Register Reference: SDZ22A/0018

Development: Construction of a mixed-use development comprising 594 apartments, office floorspace, 4 retail units, a creche and urban square in the Clonburris Development Areas CUCS3 & CSWS3 of the Clonburris SDZ Planning Scheme 2019 as follows, 594 apartments (255 one bedroom apartments, 307 two bedroom apartments and 32 three bedroom apartments (all apartments to have terrace or balcony; ancillary communal amenity spaces for residents) as follows; Block A (4 and 6 storeys with undercroft) comprises 96 apartments consisting of 36 one bedroom apartments, 48 two bedroom apartments and 12 three bedroom apartments (with creche c. 609sq. m at ground and first floor as well as play area; Block B (6 storeys with undercroft) comprises 77 apartments consisting of 44 one bedroom apartments, 28 two room apartments and 5 three bedroom apartments; Block D (5 and 7 storeys with undercroft) comprises 71 apartments consisting of 39 one bedroom apartments and 32 two bedroom apartments; Block E (6 storeys with undercroft) comprises 100 apartments consisting of 47 one bedroom apartments, 48 two bedroom apartments and 5 three bedroom apartments; Block F (5 and 7 store

Fig. 3 Homezones omitted to the South and West of Block G

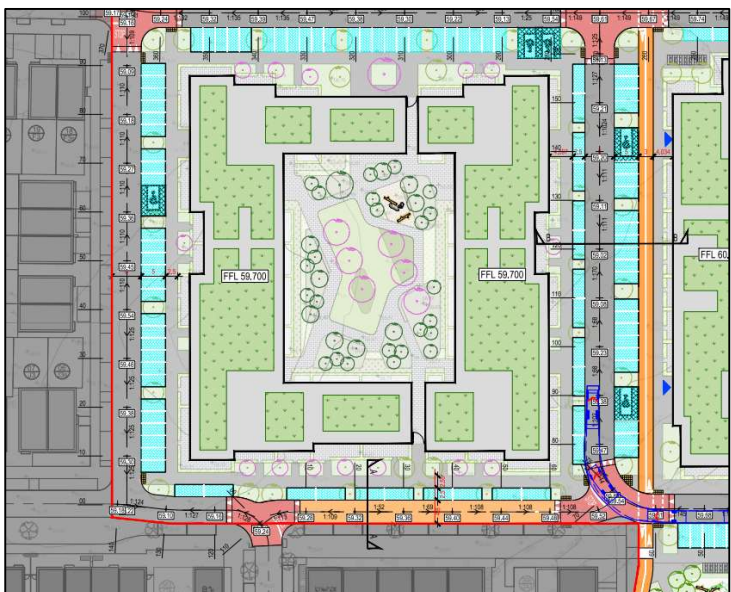
1. Homezones South and West of Block G:

This section of homezone should continue to the South Western corner of Block G before continuing along the West of Block G. The SDZ designates this street as a Homezone but the proposal is to make this a Local Street (Fig. 3). No justification has been given for this deviation.

1. The applicant is requested to submit construction/loading specifications for the reinforced grass strip along Block D and F east facades.
2. The applicant should provide justification for the inclusion of Local Streets to South and West of Block G as the SDZ plan designates these streets as a Homezones.

Fig. 5: Pedestrian permeability

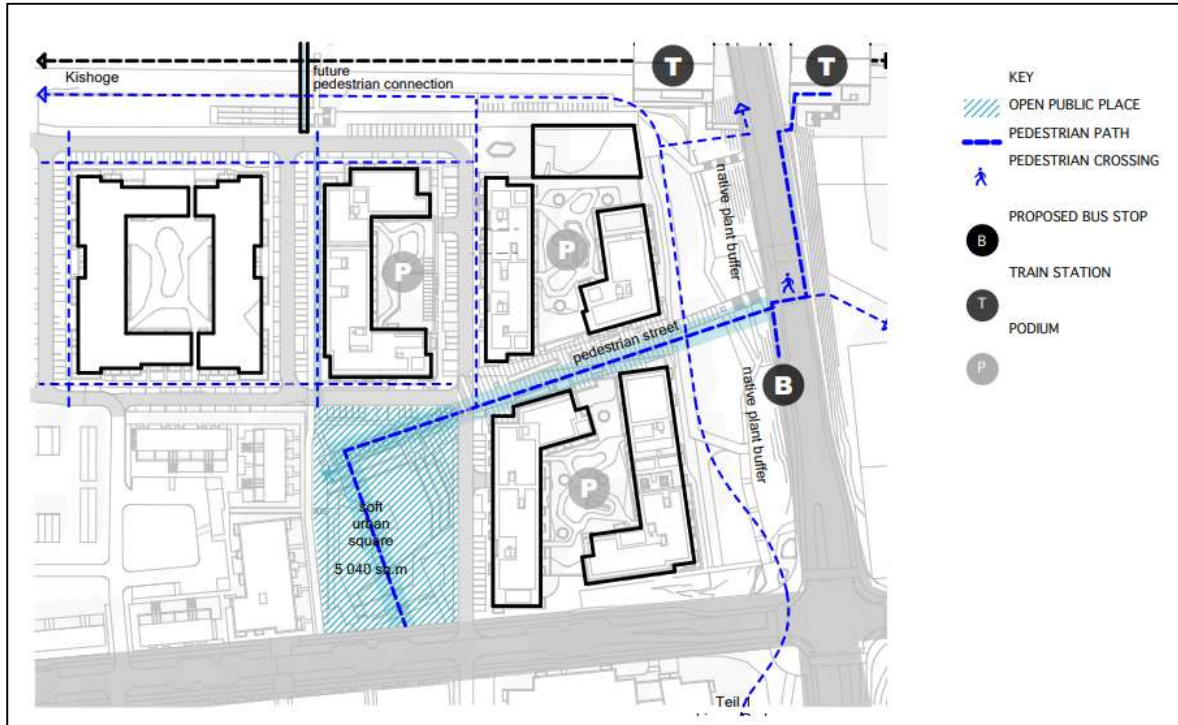
Pedestrian permeability throughout the development is good. A new pedestrian access to the Fonthill Road is proposed to connect with the proposed bus stop and to the existing train station. Changes in level are part M compliant.

Fig. 9: Proposed Bin Collection Points

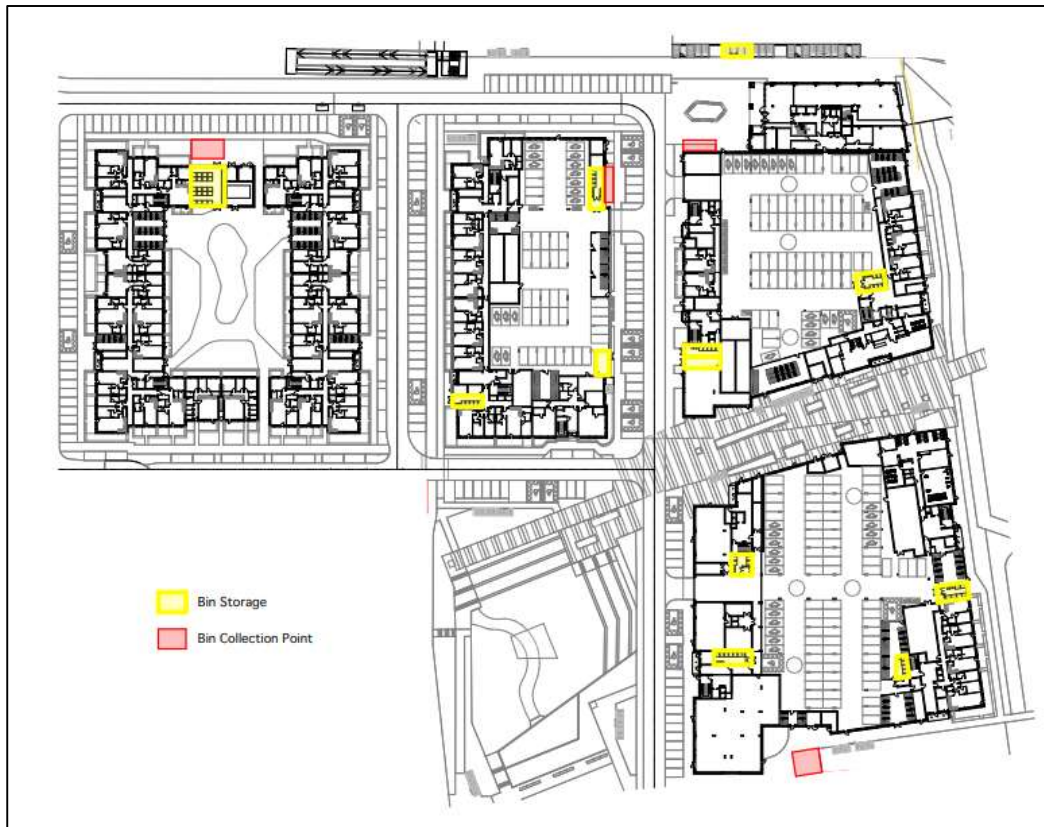
An Operational Waste Management Plan has been submitted. SDCC Roads Dept. is concerned that some of the designated Bin Collection Points are located behind parking bays which would restrict access for refuse collectors if the parking bays are in use. The applicant should submit a revised drawing showing the proposed Bin Collection Points located in areas that can be easily accessed at any time by refuse collectors. This should be accompanied by a swept path analysis showing the collection route of a refuse vehicle.

6. The applicant is requested to submit a revised drawing showing the proposed Bin Collection Points located in areas that can be easily accessed at any time by refuse collectors. Bin Collection Points should not be located behind parking bays. This should be accompanied by a swept path analysis showing the collection route of a refuse vehicle.
